CITY OF PORTLAND, MAINE
HISTORIC PRESERVATION BOARD

HISTORIC PRESERVATION BOARD AGENDA

**WORKSHOP
62 INDIA STREET**

RE: April 20, 2016 **Workshop (2nd)** – Preliminary Review of Proposed New Construction

ROOF LEVEL PLAN

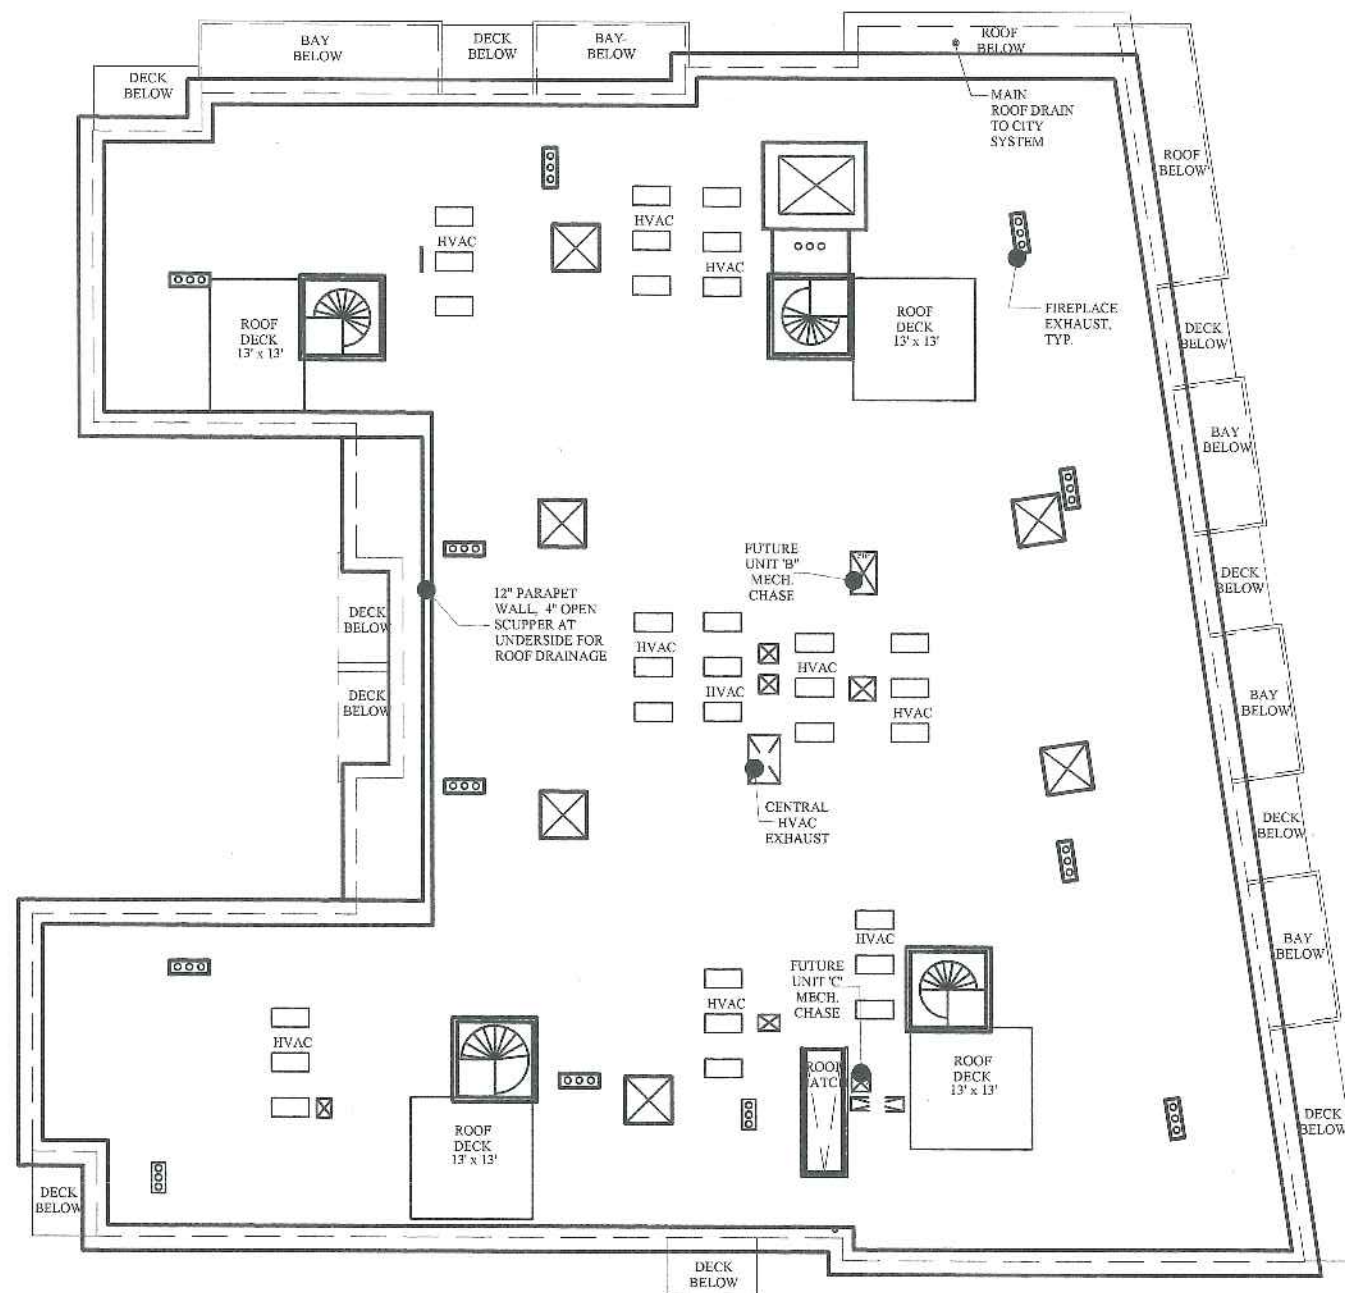
- The number of rooftop access structures has been reduced from 7 to 4 and the roof profile of the structures has been changed from sloped to a flat. A rooftop plan is provided showing the location of the structures as well as rooftop mechanicals. No wall vents are shown on the plans; the location of vents should be shown on the final submission.

A-3.1

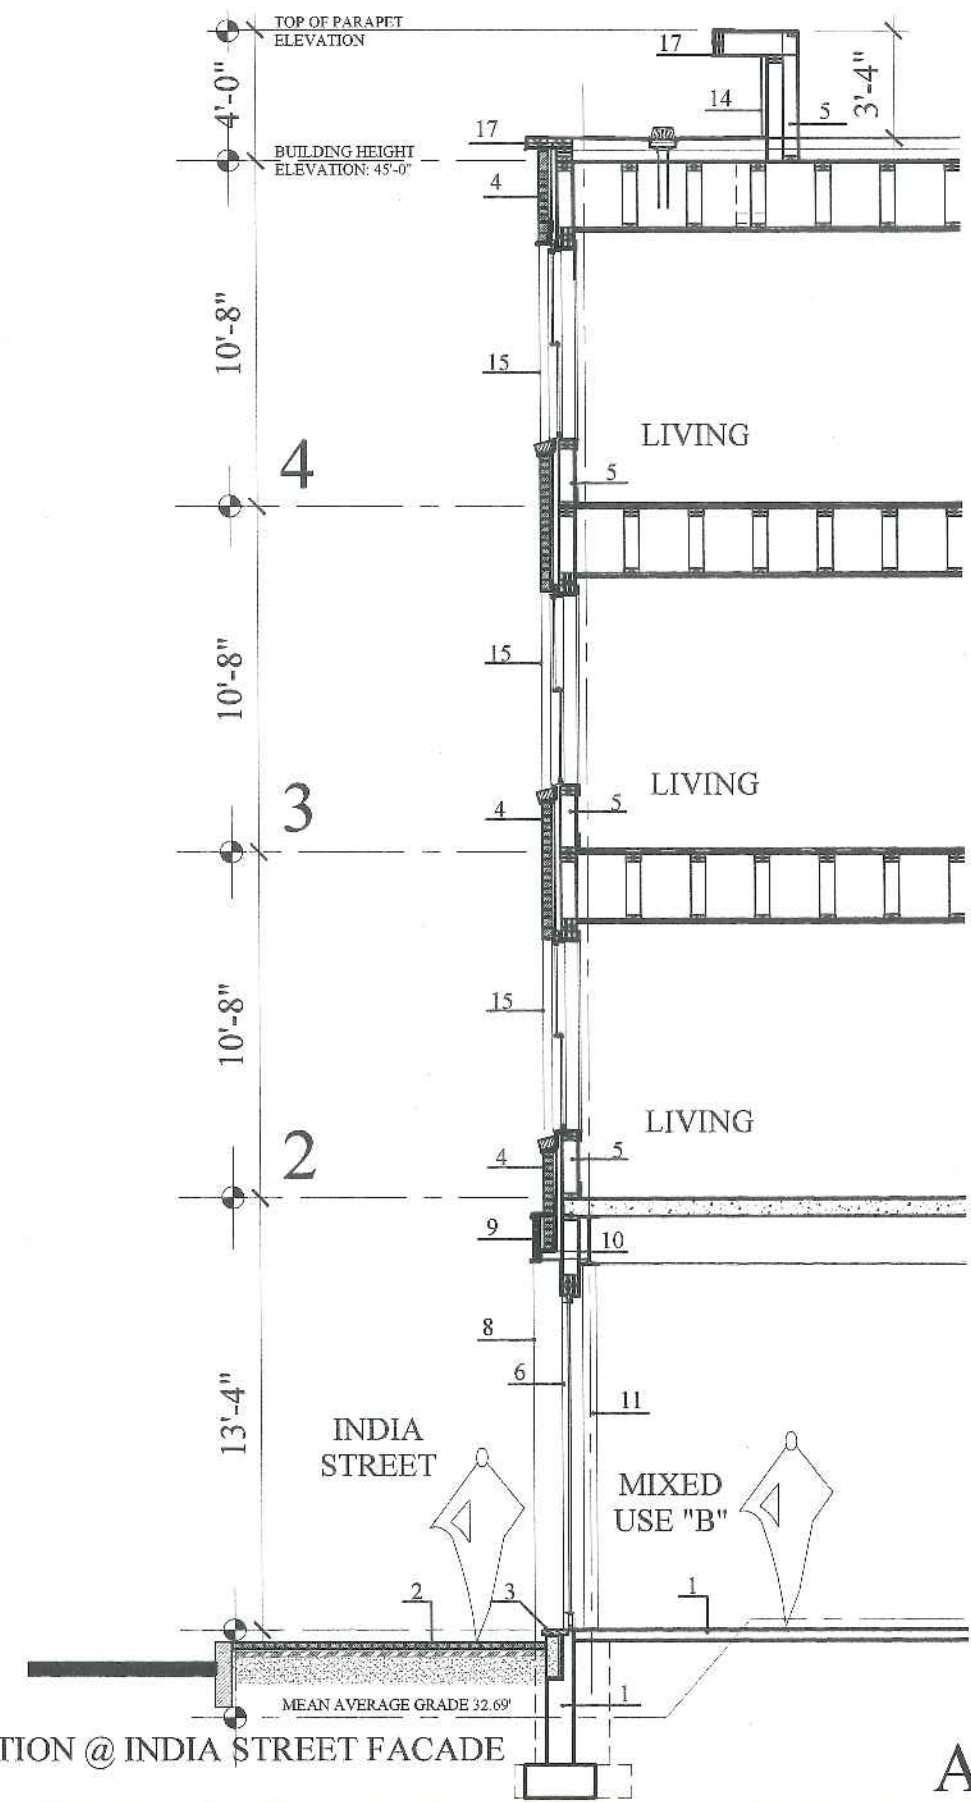
- As the wall sections on Sheets A-3.1 and A-3.3 show, the balconies railings are set back slightly from the face of the projecting bays. The railings themselves have been changed from cable railings to standard aluminum railings with vertical balusters and posts.

Balustered Railing, Shutters & Fence
 98 Carroll Street, Portland, ME
 March 2016
Sheet 04

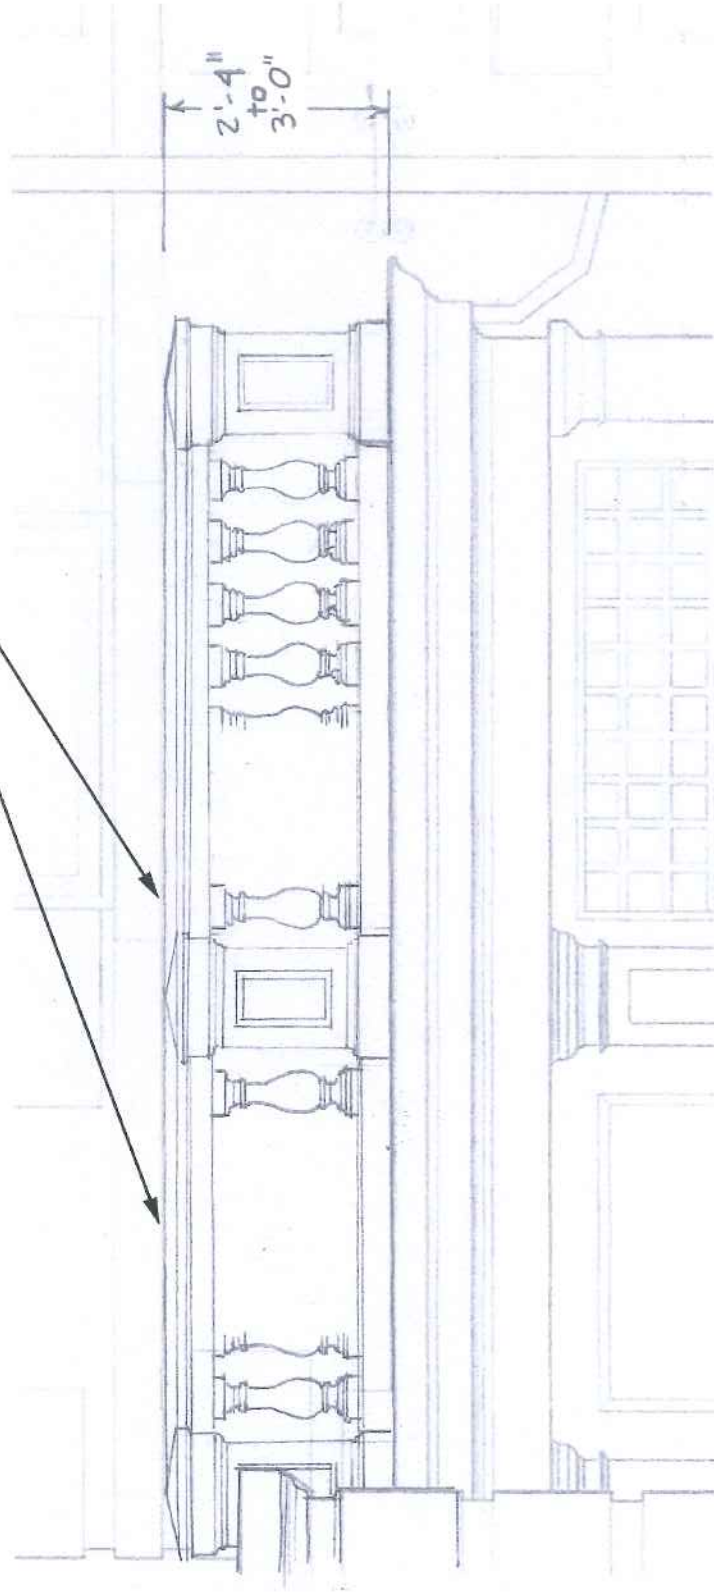
2. Replace all the second level slatted wood shutters with wood panel shutters matching the existing first level window shutters and center window shutters on the second level above the main entrance.

Storm Windows
98 Carroll Street, Portland, ME
March 2016
Sheet 09

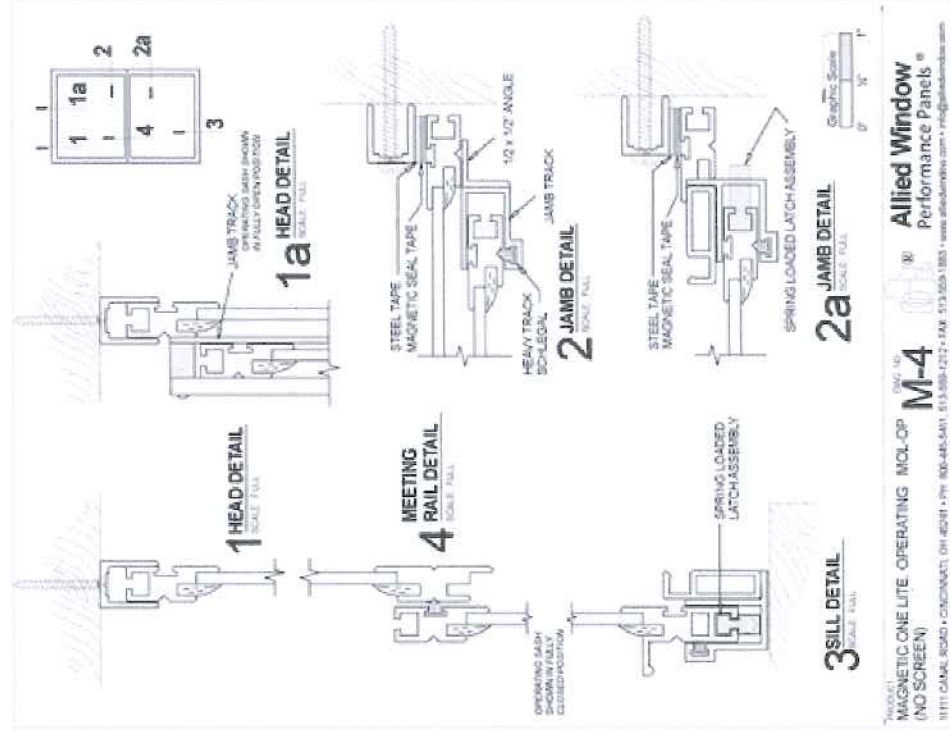
6. Remove existing exterior storm windows, repair and repaint, and install interior storm windows

CURRENT EXTERIOR DESIGN

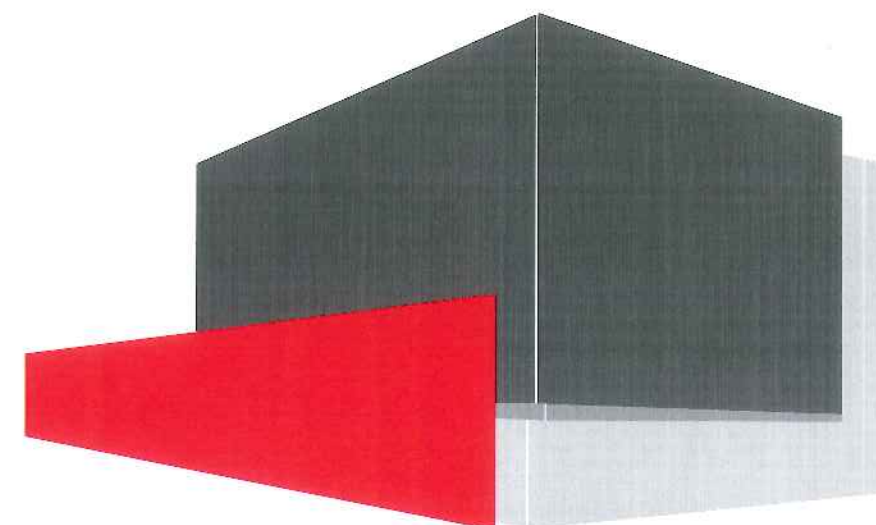
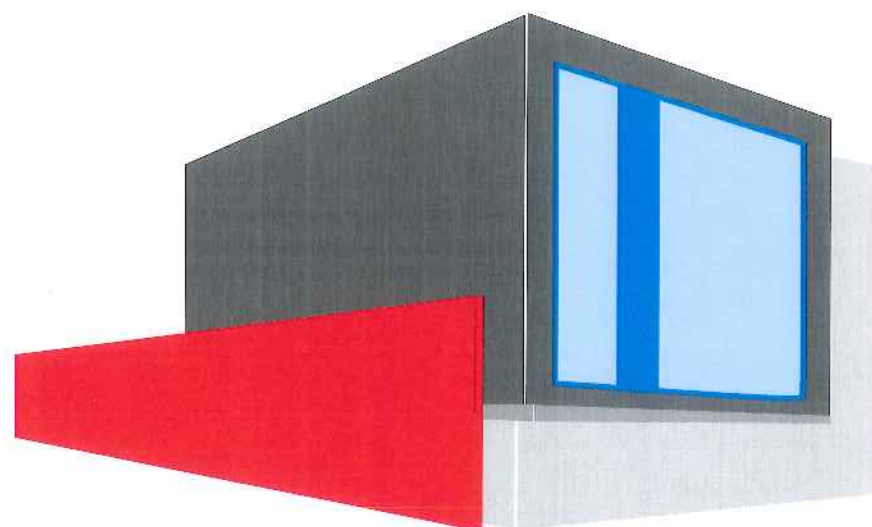
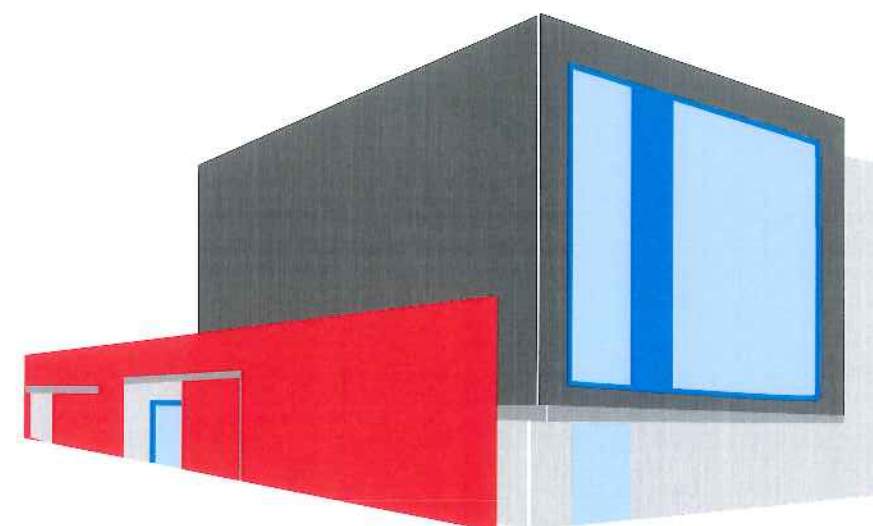
- In the previous proposal, the large glazed volume was bracketed by red brick fields on both Center and Free—see page 3. In the new proposal, the ground floor red brick façade on Center Street is retained, but the masonry on the Free Street façade has been changed to a light colored masonry. This light colored masonry-- made up of large-scale units installed in a vertical orientation—is used at the base of the Free Street elevation and extends up the tower element on the east end of this elevation. While the use of two visually distinct masonry planes is certainly consistent with the abstract nature of the overall design direction (see page 4 of submission), the Board might wish to consider the extent to which the shift to white or light masonry on the Free Street façade serves to further distinguish the building from its Free Street context. The perspective view from lower Free Street looking west clearly illustrates the effect of this color/material palette departure. A question for consideration might be whether a masonry type that more closely resembles at least the color or tonal range of traditional red brick might serve to better integrate the building with its lower Free Street context. The size of the masonry units and the vertical orientation of the installation need not necessarily change with this modification.

LIGHTING ELEMENTS

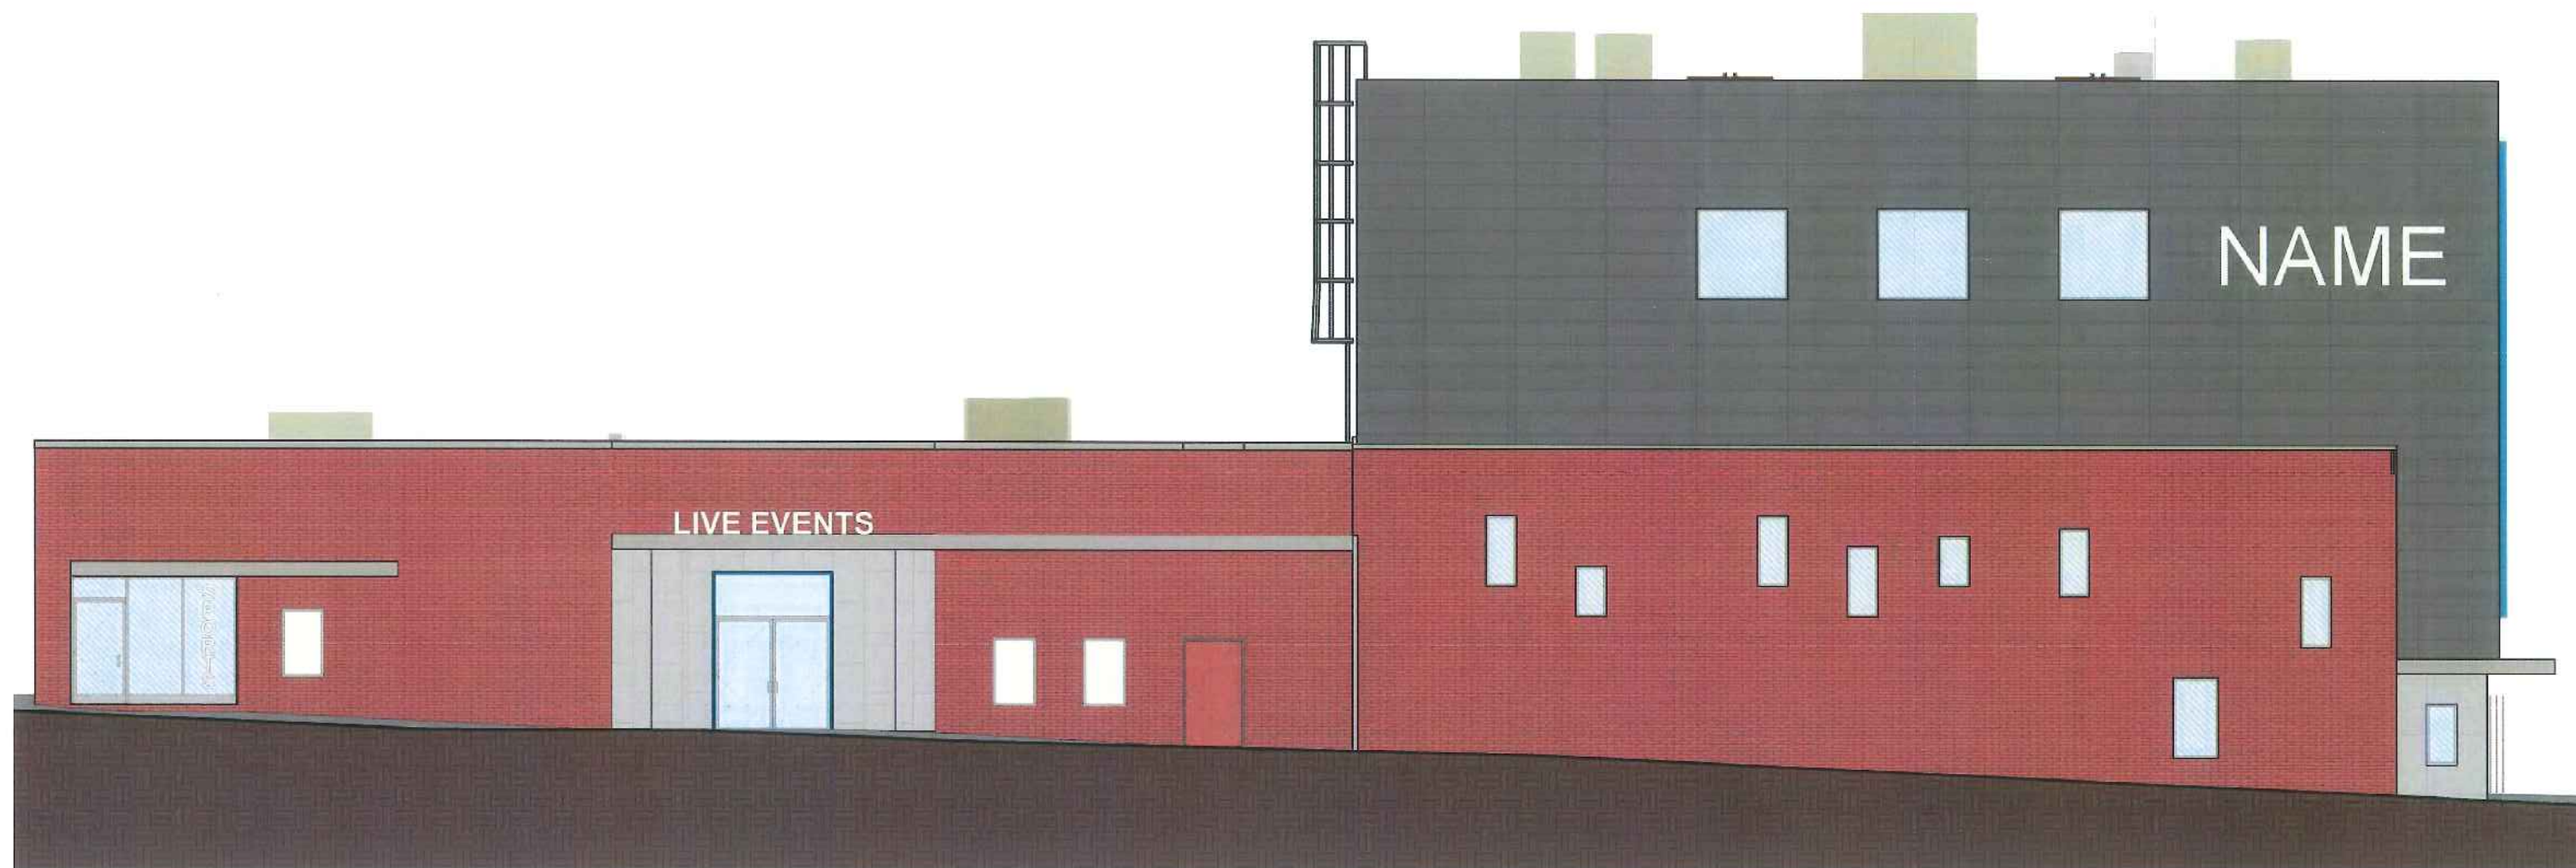
- The Board should ask for additional information regarding the proposed exterior lighting program. For example, the lighting specification sheet included in the packet calls for “exterior *color changing* LED strips”. The Board should confirm whether the color of the light will be consistent or changing. Also, the project architect should be asked to elaborate on the intended character and brightness of the lighting.

- Regarding the art wall being proposed for the Lancaster Street alley, some of the illustrations show the art being confined to former masonry openings. The illustration on the lighting specification sheet suggests that the entire wall might be reserved for graffiti. The intent should be clarified.
